JLRTB02052NAS3

TECHNICAL BULLETIN

Rear Doors Difficult To Open

MODEL:	MODEL YEAR:	VIN:	ASSEMBLY PLANT:	APPLICABILITY:
Defender (LE)	2020 Onwards	000431 Onwards	Nitra (Slovakia)	5-Door

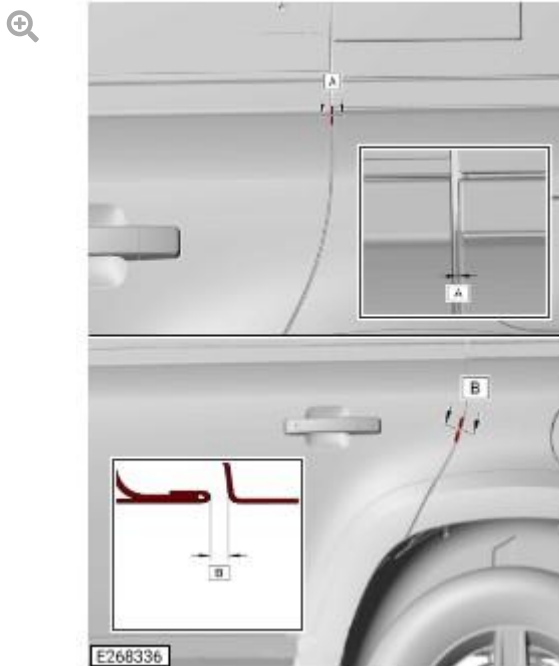
Check the alignment of the rear door(s) in the areas shown in the illustration.

SECTION	DESCRIPTION	GAP	PROFILE
A	Rear door to rear quarter	N/A	0.0 ± 0.5 mm
B	Rear door to rear quarter	3.5 ± 0.7 mm	0.0 ± 0.7 mm

Only adjust the rear doors that are either out of alignment tolerance or do not have a gap of 2.8 mm.

Adjust the rear door(s) to be as far rearward as possible while still being within tolerance, the gap must be 2.8 mm (see TOPIx Workshop Manual section 501-26: Body Repairs: Vehicle Specific Information and Tolerance Checks - General Procedures - Rear Door Alignment).

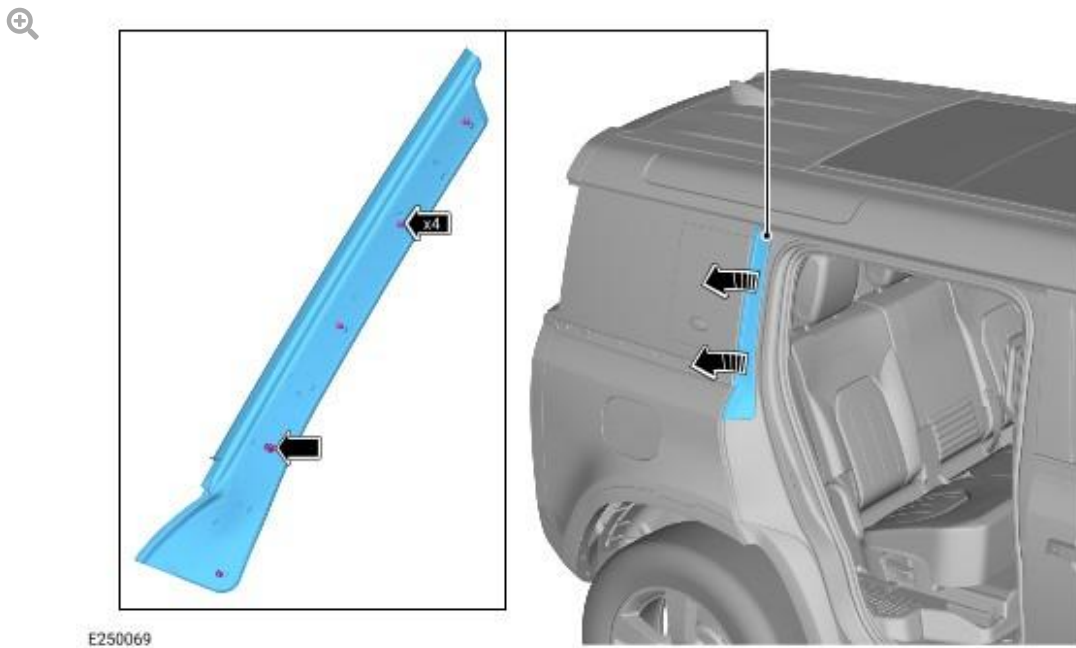
(A) Reposition the section of rear door seal shown in the illustration.

(B) Make sure the area highlighted in the illustration is clean, dry and free from contamination.

(C) Apply the double sided adhesive tape along the seal path on the door frame, as shown in illustration 'C'. Do not remove the protective backing from the double sided adhesive tape at this stage.

(D) Install the section of rear door seal removed during step 2.

(E) With the rear door seal installed, remove the protective backing from the double sided adhesive tape.

(F) Apply firm pressure to the rear door seal to make sure it is adhered to the double sided adhesive tape.
